**California Energy Commission
Perkins Renewable Energy Project
CEC Data Request Response Set #2 for the
Opt-in Application 24-OPT-01**

October 2024

Perkins Renewable Energy Project

CEC Data Request Response Set #2 for the Opt-in Application 24-OPT-01

Figure 1 Crotch's Historic and Current Range and the Perkins Renewable Energy Project

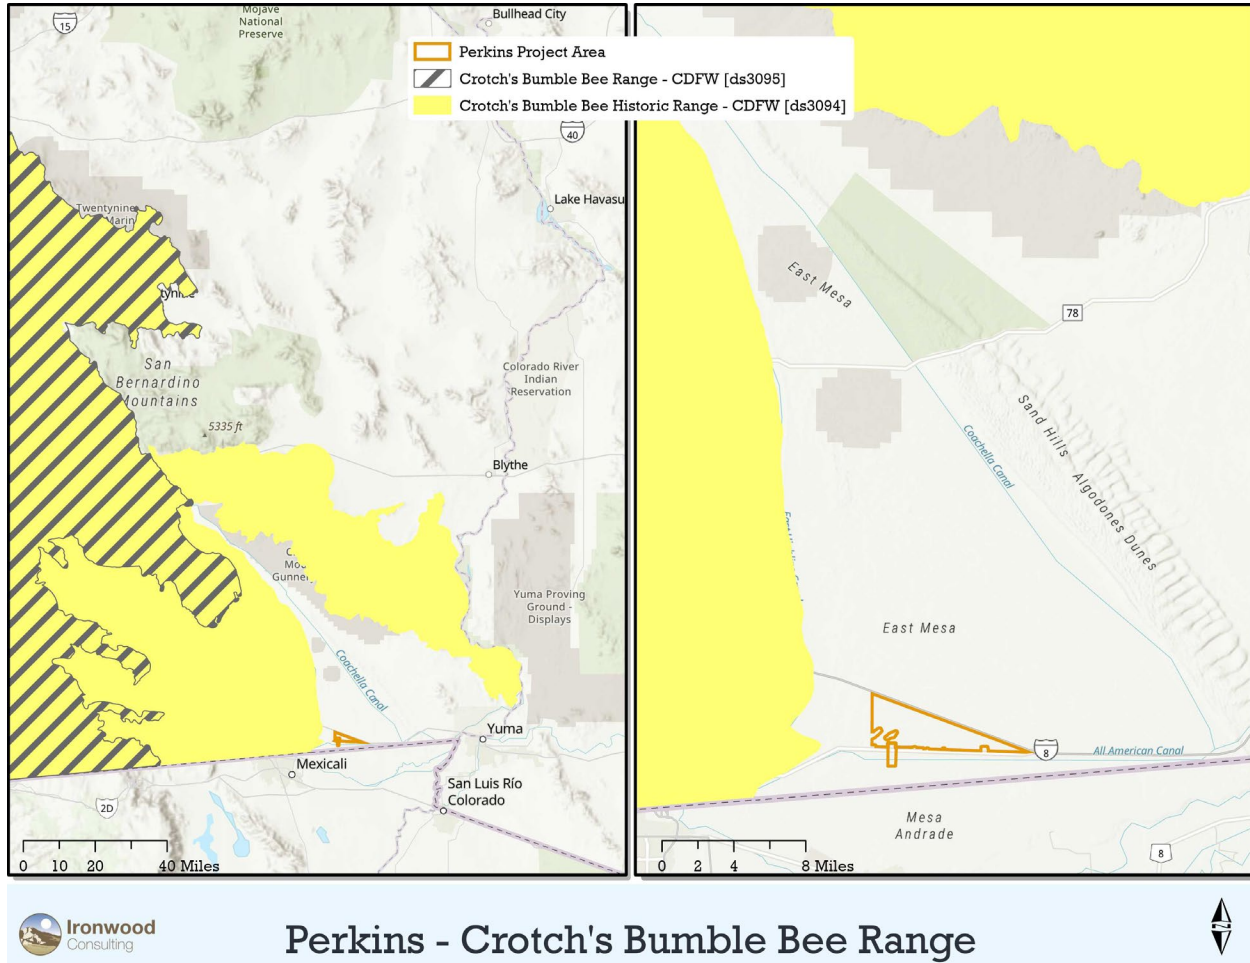
DR BIO-19: Staff needs additional information on survey methods and impact analysis for Crotch's bumble bee:

Response (Parts a-b): The Project is outside both the current and historic range of Crotch's bumble bee (Figure 1). As such Crotch's bumble bee would not occur in the Project area and the Project would have no impact on Crotch's bumble bee. The BRTR has been updated with the historic and current range.

Figure 10. Noteworthy Avian Observations.

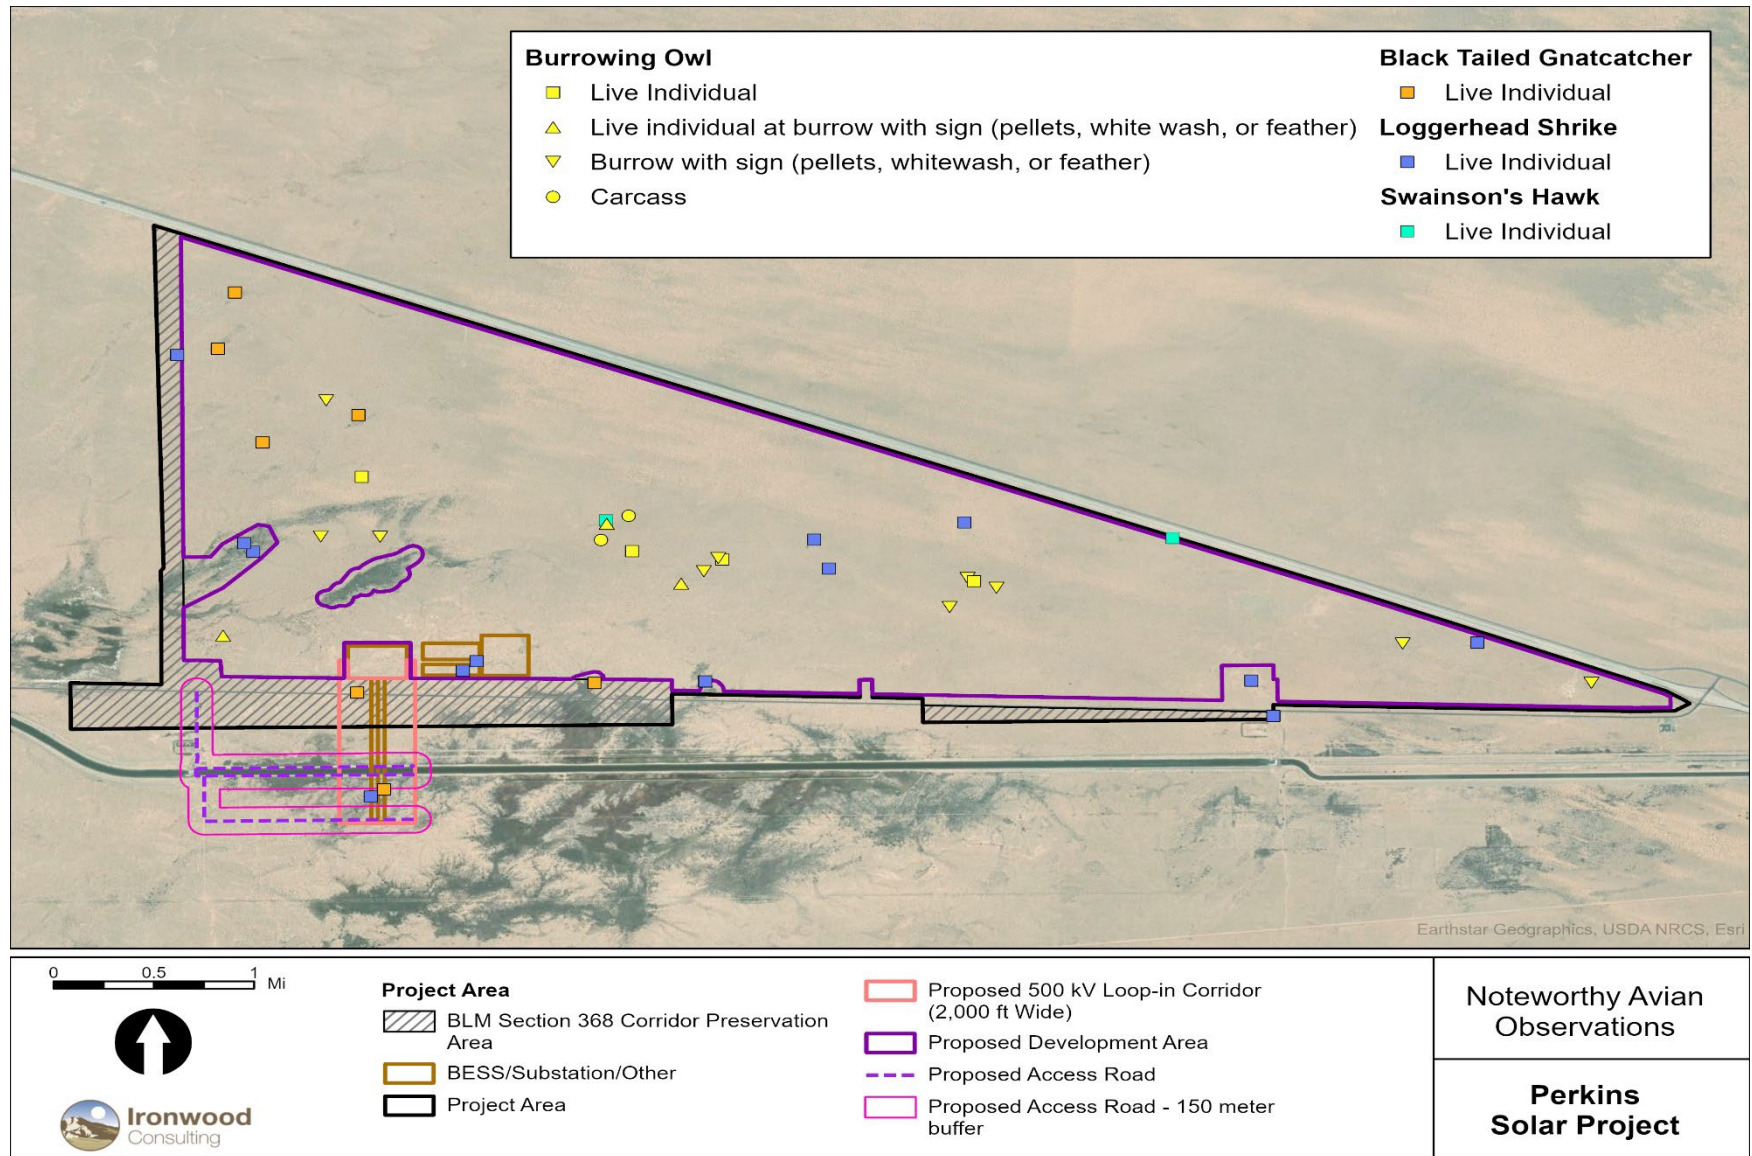
DR BIO-5: There are inconsistencies in the “Noteworthy Avian Observations” figure. Please revise the figure to define “other sign” in the legend of the “Noteworthy Avian Observations” figure included in Appendix J.3, Biological Resources Figures.

Response: The figure has been revised to define “other sign” as “pellets, whitewash, or feather”; see Figure 10 of the revised Biological Resources Technical Report, which has been included as Attachment C.1 to this Response Set #2. Appendix J.3 Figures have also been updated and are included as Attachment C.3.

Response: Figure 10 of the Biological Resources Technical Report (Attachment C.1) is the updated Noteworthy Avian Observations figure and includes the requested changes.
